STAFF REPORT: 3/16/2022 REGULAR MEETING

ADDRESS: 1068 VINEWOOD

APPLICATION NO: #22-7703

SCOPE: REPLACE SLATE ROOFING WITH NEW ASPHALT ROOFING

1068 Vinewood, current appearance

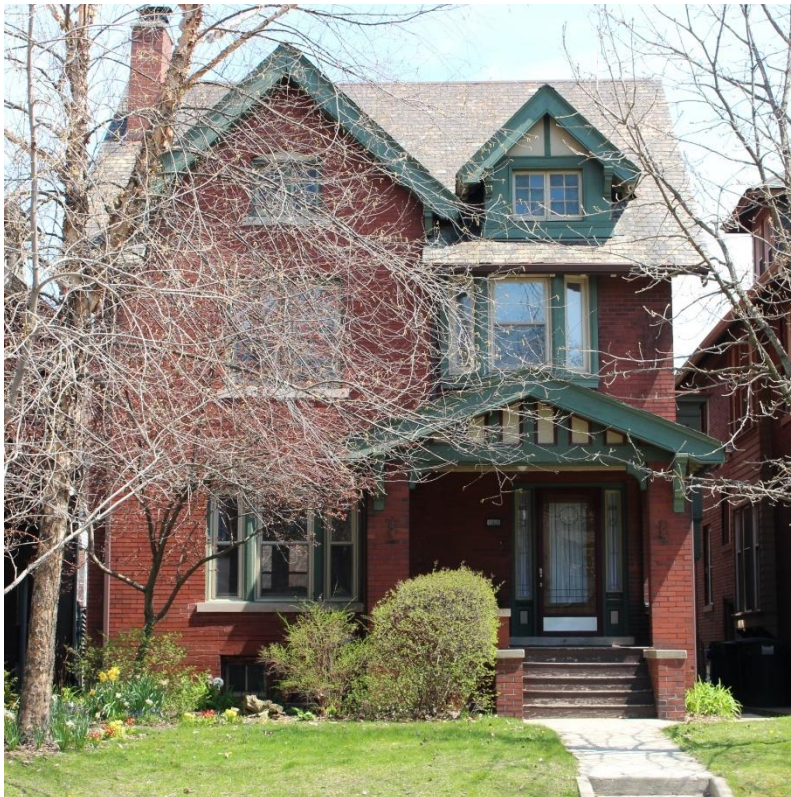
- As the home was erected ca. 1910, the current slate roof system is over 100 years old
- It is staff's opinion that the current slate roof is a distinctive character-defining feature of the home

- Staff has reviewed the submitted photos. It is staff's opinion that the slate tiles appear to be in poor condition/weathered throughout. Specifically, delamination, chipping, and cracking appears pervasive throughout the slate tile roofing

- As previously stated, it is staff's opinion that the slate roof at 1068 Vinewood is a character-defining feature of the dwelling. It is also staff's opinion that the current slate roof system has reached the end of its serviceable life and therefore merits replacement.

It is staff's recommendation that the Commission approve the issuance of a Certificate of Appropriateness for the project as proposed because it conforms to the Hubbard Farms Historic District's Elements of Design and meets the Secretary of the Interior Standards for Rehabilitation.
